Sheringham Shoal and Dudgeon Offshore Wind Farm Extension Projects

The Applicant's Comments on Responses to the
Examining Authority's Second Written Questions

Document Reference: 18.2

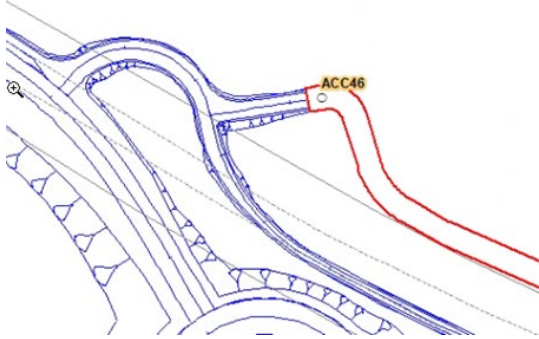
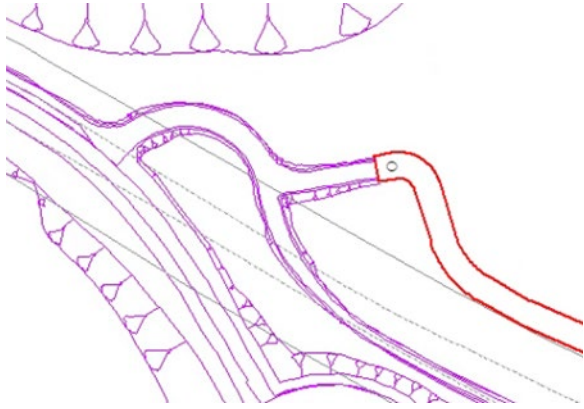
| ID | National Highways Responses | Applicant's Comment |
|---|---|--|
| 4. | <p>Overview</p> <p>Figure A, below, illustrates the extent of physical overlap between the Sheringham and Dudgeon Extension Projects DCO application and the approved A47 North Tuddenham to Easton DCO. In also shows the extent of</p> | No response required by the Applicant. |

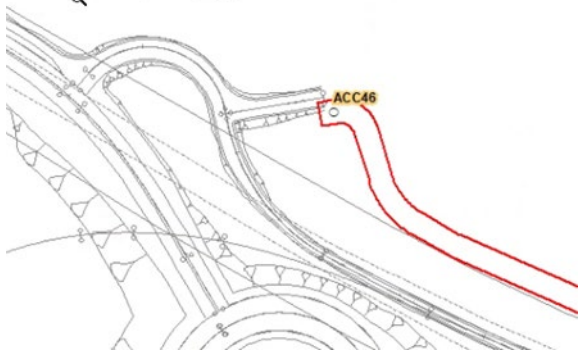
| ID | National Highways Responses | Applicant's Comment |
|----|--|--|
| 5. | <p>Taverham Road Access <u>Construction Access Corridor</u></p> <p>Figure B below shows Equinor's proposed access off the realigned Taverham Road clashes with new permanent property boundary fenceline and hedgerow with trees proposed within the A47 Tuddenham Scheme's Environmental Masterplan, Revision 4¹. This Environmental Masterplan is an approved A47 Tuddenham DCO certified document that illustrates the landscape design approved by the Secretary of State. Approval of this DCO access route for</p> | <p>Noted. The Applicant is willing to work with National Highways to ensure that there is no conflict between the projects. The Applicant considers that this can be formalised via a Cooperation Agreement. Further details are provided at ID12 below.</p> |
